# SAFETY RECALL

## SC312

**Date:** 12/18/06 (Supersedes SC312 dated 10/27/06)

**Subject:** Bulkhead-Mounted Air Manifold — CV, CT, CL, CXN and CHN Models

**Figure 2 — Air Manifold Pass-Through Connections**

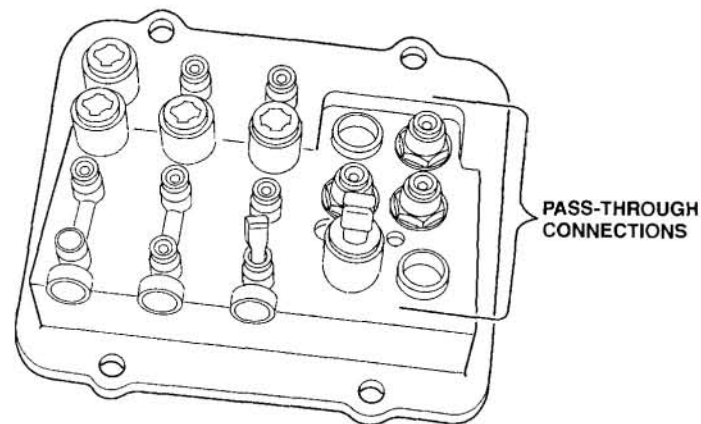
5. The manifold includes five large and three small pass-through holes. Depending upon chassis equipment, the large holes are used for certain air connections such as the fifth wheel air control switch, PTO control valve, air suspension control valve, etc. The three small holes are used for exhaust lines, and for the supply line from the pressure protection valve to the dashboard air switches. Push-to-connect bulkhead fittings are installed in the large holes when used for pass-through connections, and closure plugs are installed in any unused holes.

REV

Clearly mark to identify the air lines connected to each of the pass-through bulkhead fittings, and then use the push-to-connect release tool (tool No. 9032-1800TRK) to disconnect the lines from the fittings. This tool is available through the MACK Parts System. The lines must be clearly marked to ensure they are reconnected to the correct ports on the replacement manifold.
